# Access Compliance Report

## Public Rights-of-Way

Intersection ID: 32307	Main Street: BRIDGEVIEW_LN	Cross Street: NEW_PROVIDENCE_LN	Location: NE
ADA ID: E5495037689C	Ramp Type: PerpDiag	Initial Pass/Fail: Fail	Overall Compliance: No
Severity Score: 22.5			
Codes/Mitigation Info/Possible Solution		Field Measurements/Component Compliance

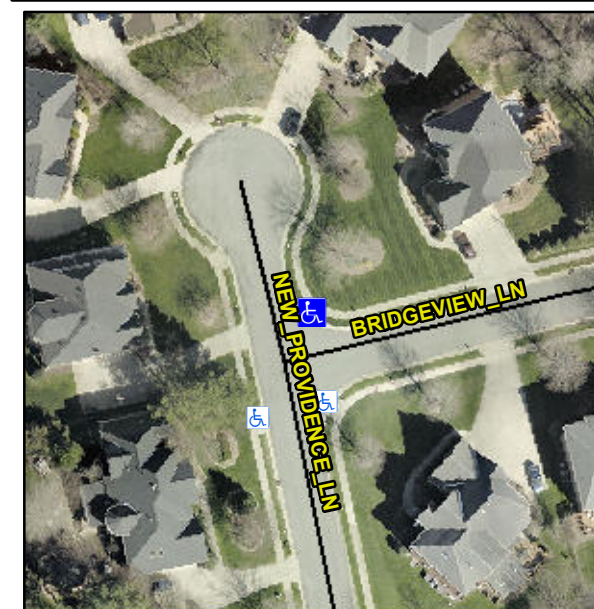
**R304.5.1, R304.2.2, R304.5.3**

Compliance	Description	Data	Compliance	Description	Data
N/A	Ramp Length (in)	46.5	No	Ramp Slope (%)	8.5
No	Ramp Width (in)	44.0	No	Ramp XSlope (%)	4.2
N/A	Flare Type LT	N/A	N/A	Flare Type RT	N/A
N/A	Flare Slope LT (%)	N/A	N/A	Flare Slope RT (%)	N/A
N/A	Flare Traversable LT?	N/A	N/A	Flare Traversable RT?	N/A
N/A	Landing Length (in)	N/A	N/A	DWS Provided?	N/A
N/A	Landing Width (in)	N/A	N/A	DWS Contrast?	N/A
N/A	Landing Slope (%)	N/A	N/A	DWS Length (in)	N/A
N/A	Landing X Slope (%)	N/A	N/A	DWS Full Width?	N/A
N/A	Landing Curb? (Y/N)	N/A	N/A	DWS Offset (in)	N/A
N/A	Shared Landing?	N/A			
N/A	Gutter Ponding?	N/A	N/A	Gutter Slope (%)	N/A
N/A	Gutter Lip Ht (in)	N/A	N/A	Gutter X Slope (%)	N/A
N/A	Painted X Walk1?	No	N/A	Painted X Walk2?	No
	X Walk 1 Direction	To W		X Walk 2 Direction	To S
N/A	X Walk 1 Width (in)	N/A	N/A	X Walk 2 Width (in)	N/A
	X Walk 1 Slope (%)	1.4		X Walk 2 Slope (%)	4.2
	X Walk 1 X Slope (%)	5.7		X Walk 2 X Slope (%)	3.1

N/A	Ramp inside XWalk1?	N/A	N/A	Ramp inside XWalk2?	N/A
	Road Slope (%)	3.2	N/A	Clear Space?	N/A
	Road X Slope (%)	4.9	N/A	Clear Space to XWalk (in)	N/A
N/A	Any Obstructions?	N/A	N/A	Storm Grate/Utility Hazard?	N/A
	Obstruction Type			Storm Grate/Utility Type	
		N/A			N/A
			Yes	Surface Condition? (G/P)	Good

**Remove & Replace Curb Ramp With Two New Directional Ramps or Equivalent.**
